# Work Order ID 88808

Item Name: Crosstube Aft

<b>DART AEROSPACE LTD</b>	<b>Work Order:</b>	<i>88808</i>
<b>Description:</b> Crosstube High Aft (205/212)	<b>Part Number:</b>	<b>D212-664-201</b>
<b>Inspection Dwg:</b> D212-664-241	<b>Rev:</b> D	<b>Page 1 of 1</b>

DRAWING NO. D212-664-241	TITLE CROSSTUBE ASSY (205/212 HI AFT)	REV. D	DART AEROSPACE LTD ENGINEERING ORDER		D.E.O. NO. D212-664-241-D-1	SHEET NO. SHEET 1 OF 2	SCALE NTS
DRAWN	CHECKED	MFG. APPR.	APPROVED	DE APPR.			
DATE 11.04.07	DATE 11.04.11	DATE 11.04.12	DATE 11/04/12	DATE 11.04.12

**FIGURE 1: SUPPORT INSTALLATION**

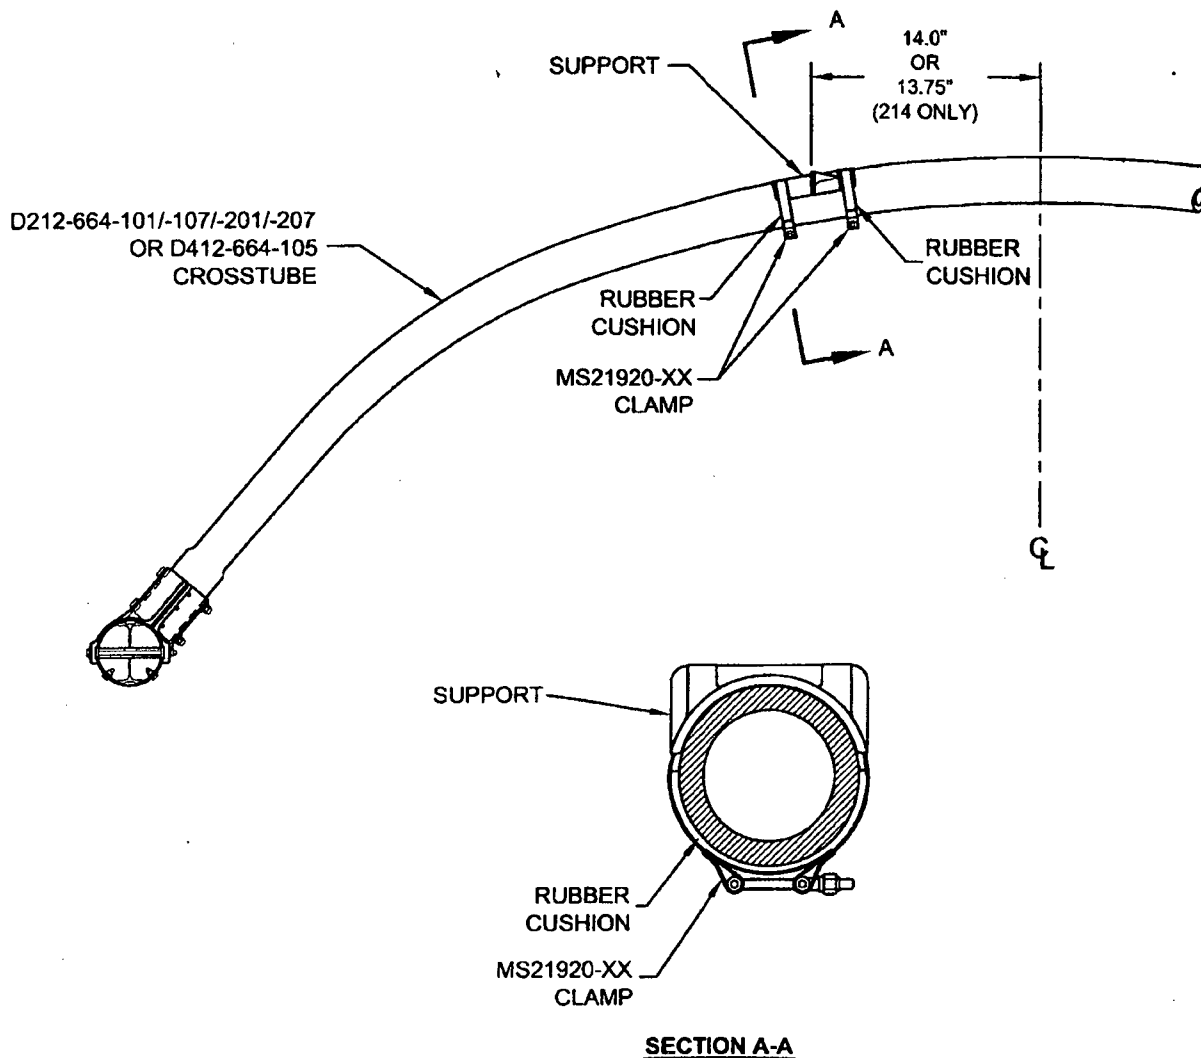
The supports on the following crosstubes are now installed using Proseal instead of Magnobond:

For the crosstubes listed above, section 32.4 of ICA-D212-664 is amended as follows. Use Figure 1 of this service instruction and Figures 32-2 to 32-9 of ICA-D212-664 for further reference. For crosstubes of an earlier change number, it is recommended that if the supports are removed, the supports should be reinstalled using the procedure listed below.

- 32.4.1 Locate the area on the crosstube for installation of support (see Figure 1 of this service instruction). For D212-664-101/-107/-201/-207 and D412-664-105 crosstubes, the outward face of the support tabs should be 14.0" (355mm) from the crosstube center for 204/205/210/412/UH-1 aircraft. For installation on 214B/B-1 aircraft, the outward face of the support tabs should be 13.75" (349mm). Ensure paint finish of crosstube is intact; touch up as required per Chapter 5 (5.3.9) of ICA-D212-664.

- 32.4.2 If present, remove any paint/primer on bottom of supports. Abrade mating surfaces of support and crosstube with 400-grit sandpaper. Saturate a clean cloth with MEK or 4105S Wash'n'Wipe Degreaser or equivalent and wipe until there is no residue.

- 32.4.3 Ensure a layer of 3M Scotch-Weld 2216 B/A Epoxy Adhesive is on the bottom of the support. If required, either apply or touch-up support to have a 0.03" to 0.05" thick layer of adhesive over the entire mating surface. Allow supports to cure for 24 hours.

- 32.4.4 Abrade mating surfaces of support (after cure) and crosstube with 180-grit sandpaper. Saturate a clean cloth with MEK or 4105S Wash'n'Wipe Degreaser or equivalent and wipe until there is no residue.

- 32.4.5 Apply a 0.04" to 0.07" thick layer of Proseal 890 Class B or AMS-S-8802 Class B sealant underneath applicable support and install support as shown in Figure 1 of this service instruction.

- 32.4.6 Install the clamps opposite to crosstube support as shown in section A-A of Figure 1. Install rubber cushions underneath each clamp around the bottom circumference of the crosstube up to the crosstube centerline. Torque clamps 80-100 in-lb (9.0-11.3 Nm). It is acceptable to use smaller or larger sized MS21920-XX clamps than those listed in ICA-D212-664, ensure that after torquing the clamps per this instruction, the nuts are in safety but not bottomed out

- 32.4.7 Prior to installing crosstube on aircraft, allow supports to cure for 72 hours and recheck torque on clamps.

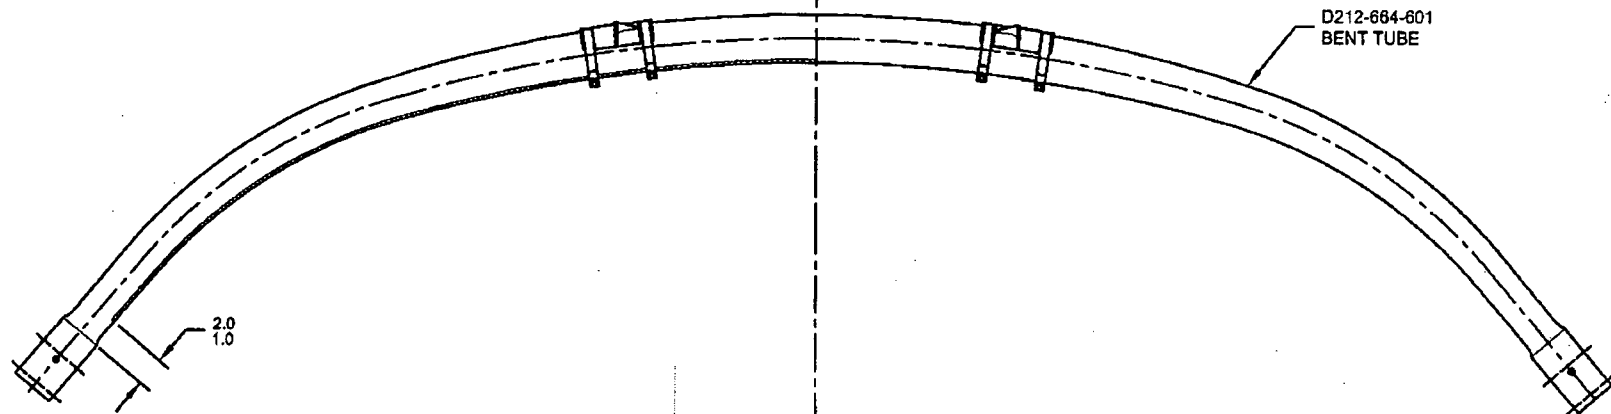
ADD AN INSPECTION WINDOW TO UNDERSIDE OF CROSSTUBE.

NOTES 2 OF SHEET 1 IS AMENDED AS FOLLOWS:

- 2) FINISH: CHEMICAL CONVERSION COAT PER DART QSI 005 4.1  
PRIME INSIDE AND OUTSIDE PER DART QSI 005 4.2  
MASK UNDERSIDE OF CROSSTUBE AS SHOWN (HATCHED AREA) AND  
PAINT OUTSIDE PER DART QSI 005 4.2  
REMOVE MASKING AND APPLY CLEAR COAT

**D212-664-241-241B  
ASSEMBLY DETAIL**

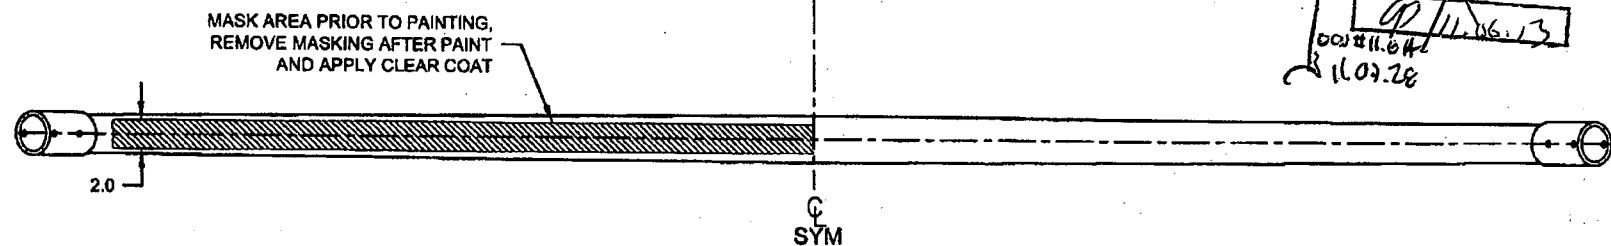
**WAS:**

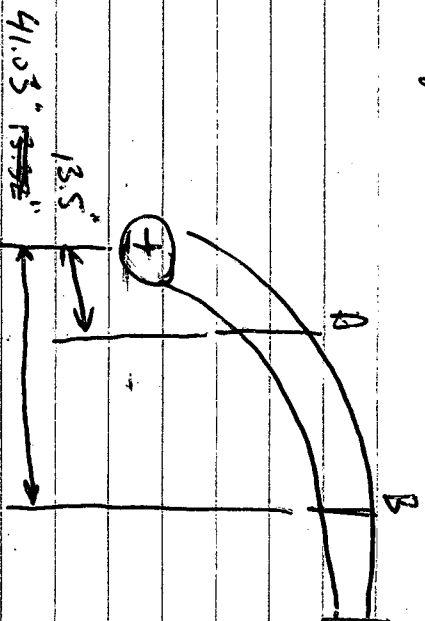
REPLACE MAGNOBOND WITH PROSEAL.

NOTE 12 & 15, SHEET 1 IS AMENDED AS FOLLOWS:

- 12) TO INSTALL D2940-1 SUPPORT: ABRASE MATING SURFACE OF SUPPORT AND CROSSTUBE WITH 180-GRIT SANDPAPER AND REMOVE RESIDUE WITH MEK (OR EQUIVALENT). APPLY A 0.04" TO 0.07" THICK LAYER OF PROSEAL 890 CLASS B-2 (OR AMS-S-8802 CLASS B-2) SEALANT TO MATING SURFACE OF SUPPORT.
- 15) TORQUE CLAMPS 80 TO 100 IN-LB. ENSURE AT LEAST 1.5 THREADS SHOWING IN SAFETY AND THAT NUT HAS NOT BOTTOMED-OUT AFTER TORQUING. **PRIOR TO PACKAGING, RE-CHECK TORQUE ON CLAMPS AFTER PROSEAL 890 SEALANT HAS CURED FOR 72 HOURS.**
